## **RANGELINE BUSINESS PARK SUBDIVISION**

***Revised for the August 16<sup>th</sup> meeting:***

APPLICATION NUMBER 10 DATE August 16, 2006

# DETAIL SITE PLAN

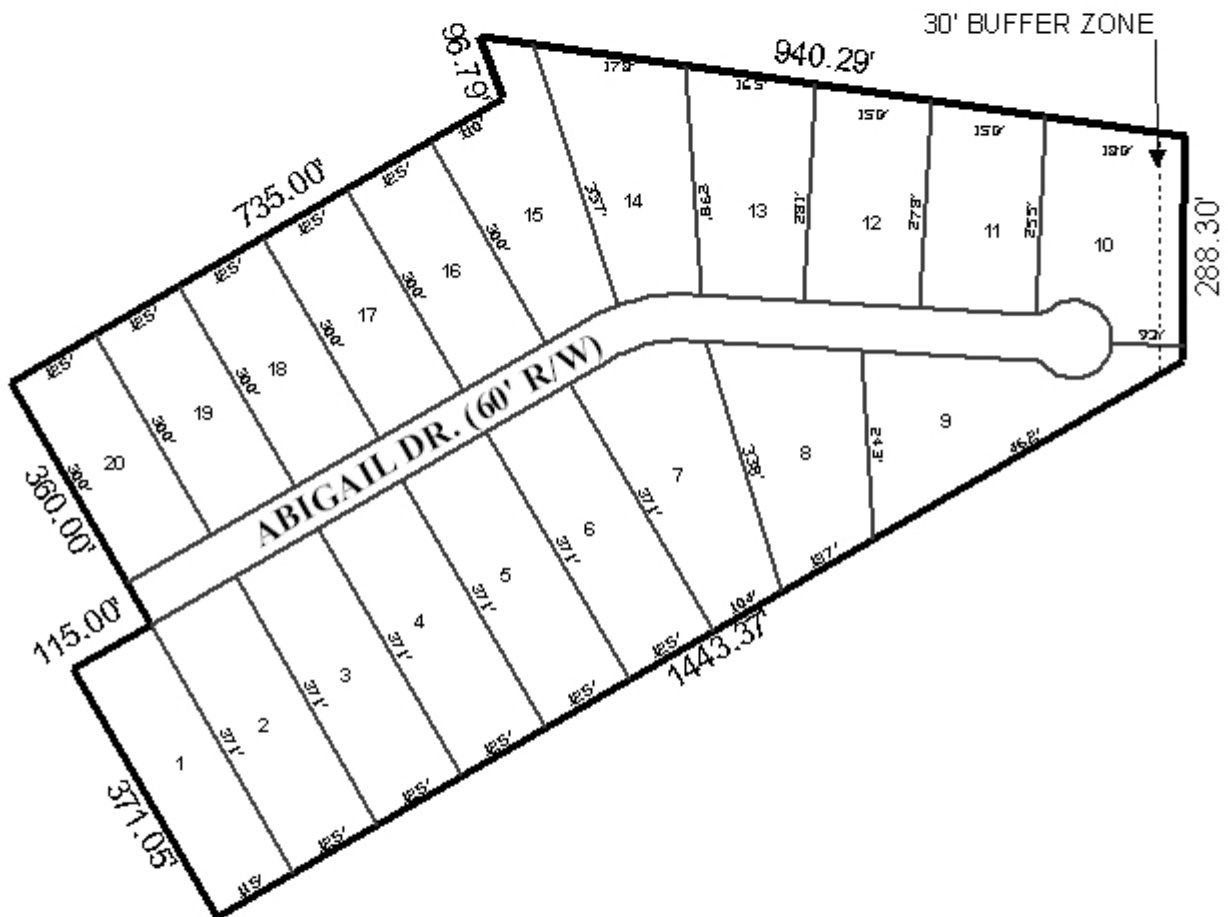
A residential subdivision, Riverwood Estates, Phase Three, is proposed along the Northeastern boundary of the site. Dimensions and bearings from the tentatively approved plat for Riverwood Estates, Phase Three indicate that there is a discrepancy between the residential plat and the Rangeline Business Park plat: the discrepancy between the plats should be resolved prior to any further review by the Planning Commission.

Due to the limited width of each lot, each lot should be restricted to one curb-cut, with the size, design and location to be approved by the Mobile County Engineering Department.

- 1) revision of the plat to ensure that the boundary line between the proposed Riverwood Estates Subdivision, Phase Three, and the proposed Rangeline Business Park Subdivision match;

- 2) revision of the plat to label each lot with its size in square feet, or placement of a table on the plat with the same information;
- 3) placement of a note on the plat stating that each lot is limited to one curb-cut, with the size, design and location to be approved by Mobile County Engineering Department;

- 5) revision of the plat to depict and label common area detention facilities, if required; and
- 6) placement of a note on the final plat stating that any lots which are developed commercially and adjoin residentially developed property must provide a buffer, in compliance with Section V.A.7 of the Subdivision Regulations.

*The application was heldover until the August 16<sup>th</sup> meeting, at the applicant's request. A revised plat was submitted, resolving the boundary issue.*

*The proposed cul-de-sac, at 1,360 feet just within this subdivision, will exceed the length recommended by Section V.B.6. of the Subdivision Regulations. Furthermore, the site is within the City of Mobile Fire-Rescue jurisdiction, thus the design of the cul-de-sac must comply with the requirements of Mobile Fire-Rescue. Approval by the Planning Commission should be contingent upon the subdivision complying with the requirements of Mobile Fire-Rescue.*

- 1) revision of the plat to reflect any requirements of the City of Mobile Fire-Rescue Department regarding the design of Abigail Drive;*
- 2) construction of Abigail Drive to Mobile County standards, and dedication of the road to Mobile County;*

- 3) revision of the plat to label each lot with its size in square feet, or placement of a table on the plat with the same information;*
- 4) placement of a note on the plat stating that each lot is limited to one curb-cut, with the size, design and location to be approved by Mobile County Engineering Department;*

- 6) revision of the plat to depict and label common area detention facilities, if required, and the provision of a note stating that the maintenance of said facilities is the responsibility of the property owners;*

*With a waiver of Section V.B.6., contingent upon compliance with requirements of Mobile Fire-Rescue, the revised plat is recommended for Tentative Approval, subject to the following conditions:*
